Subject: Change of label for FT600 series

PCN number : 22082016

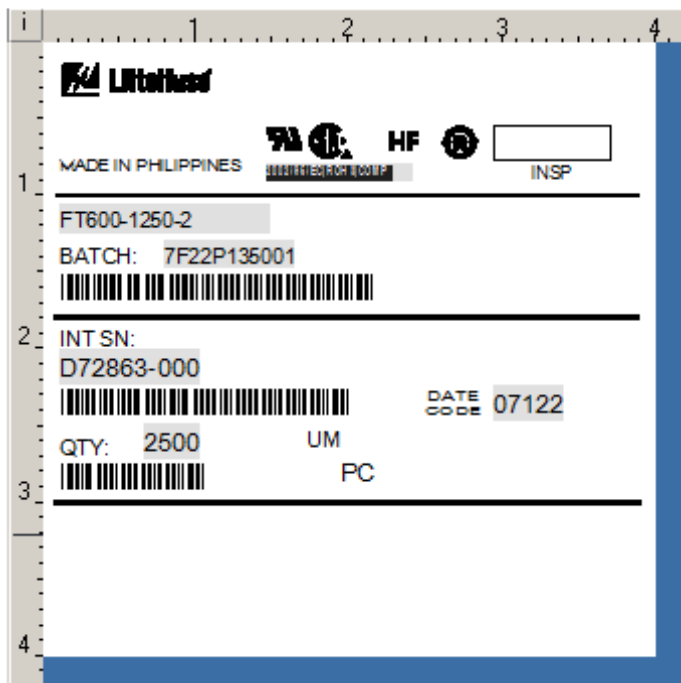
Please see below on the FT600 labels with Littelfuse logos.

We will be implementing the attached labels on 15th Sept on the fuses leaving our Plant. This will be a rolling change on 15<sup>th</sup> September 2016 in our Plant.
